Access Compliance Report

Public Rights-of-Way

Intersection ID: N/A	Main Street: PROVIDENCE_RD	Cross Street: N/A	Location: SE
ADA ID: 0AD7AFC36AE6	Ramp Type: BlendTrans2	Initial Pass/Fail: Fail	Overall Compliance: No
		Severity Score: 1.25

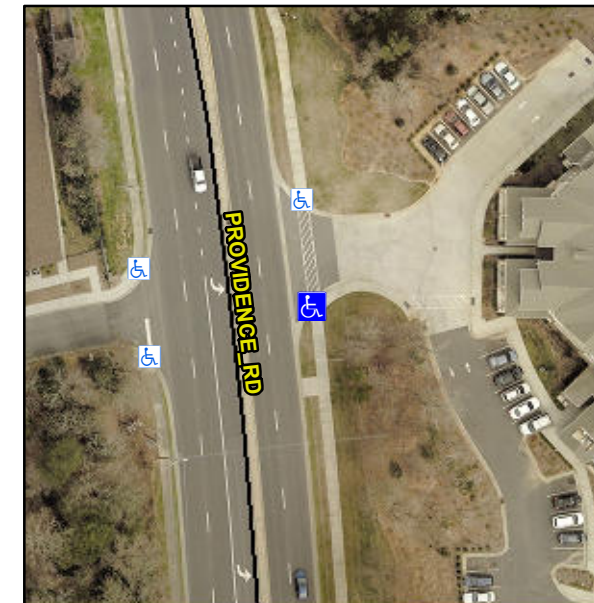
R304.5.3

Compliance	Description	Data	Compliance	Description	Data
N/A	Ramp Length (in)	63.5	Yes	BlendTrans Slope (%)	1.3
Yes	Ramp Width (in)	48.0	No	BlendTrans XSlope (%)	2.3
N/A	Flare Type LT	N/A	N/A	Flare Type RT	N/A
N/A	Flare Slope LT (%)	N/A	N/A	Flare Slope RT (%)	N/A
N/A	Flare Traversable LT?	N/A	N/A	Flare Traversable RT?	N/A
N/A	Landing Length (in)	N/A	N/A	DWS Provided?	N/A
N/A	Landing Width (in)	N/A	N/A	DWS Contrast?	N/A
N/A	Landing Slope (%)	N/A	N/A	DWS Length (in)	N/A
N/A	Landing X Slope (%)	N/A	N/A	DWS Full Width?	N/A
N/A	Landing Curb? (Y/N)	N/A	N/A	DWS Offset (in)	N/A
N/A	Shared Landing?	N/A			
N/A	Gutter Ponding?	N/A	N/A	Gutter Slope (%)	N/A
N/A	Gutter Lip Ht (in)	N/A	N/A	Gutter X Slope (%)	N/A
N/A	Painted X Walk1?	Yes	N/A	Painted X Walk2?	N/A
	X Walk 1 Direction	To N		X Walk 2 Direction	N/A
	X Walk 1 Width (in)	66.0		X Walk 2 Width (in)	N/A
	X Walk 1 Slope (%)	1.9		X Walk 2 Slope (%)	N/A
	X Walk 1 X Slope (%)	2.5		X Walk 2 X Slope (%)	N/A

Remove & Replace Curb Ramp With Two New Directional Ramps or Equivalent.
